SERVICE INFORMATION

No. SI-F84011
Date: February, 1984

PR-7820 Inside Limit Adjustment

Change of Alignment Procedure

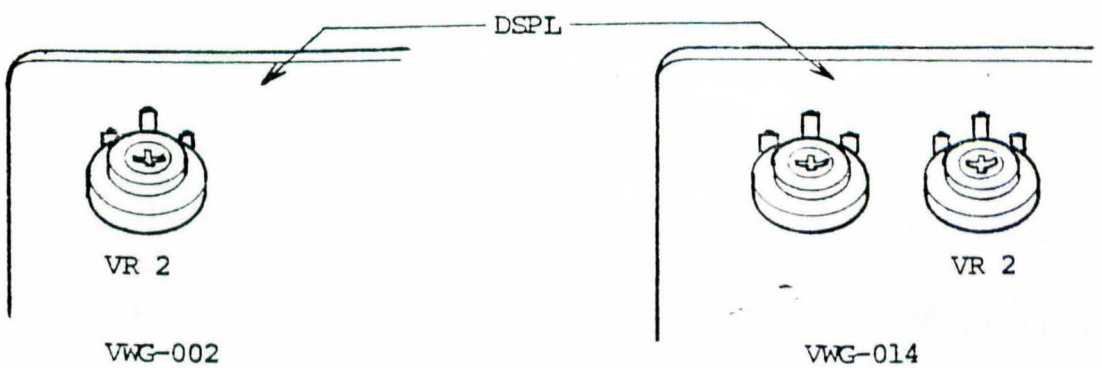
1. Turn the Power On and play B1 Test Disc.
2. With the unit in PLAY MODE, SCAN FORWARD to a point on the disc above Frame #1000, then SCAN REVERSE towards inside until the player hits the INSIDE LIMIT.

a) PR-7820 III will kick back a few frames when it reaches the INSIDE LIMIT.

b) PR-7820 I and PR-7820 II will be in STILL MODE at the INSIDE LIMIT.
3. Adjust VR2 on DSPL Board so that the Kick Back Point (Still Mode for Type I and II) will be between #10 to #15 in the LEAD IN Count Down Numbers. (Note: These are the numbers which appear on the TV Monitor, not the Frame Numbers.)
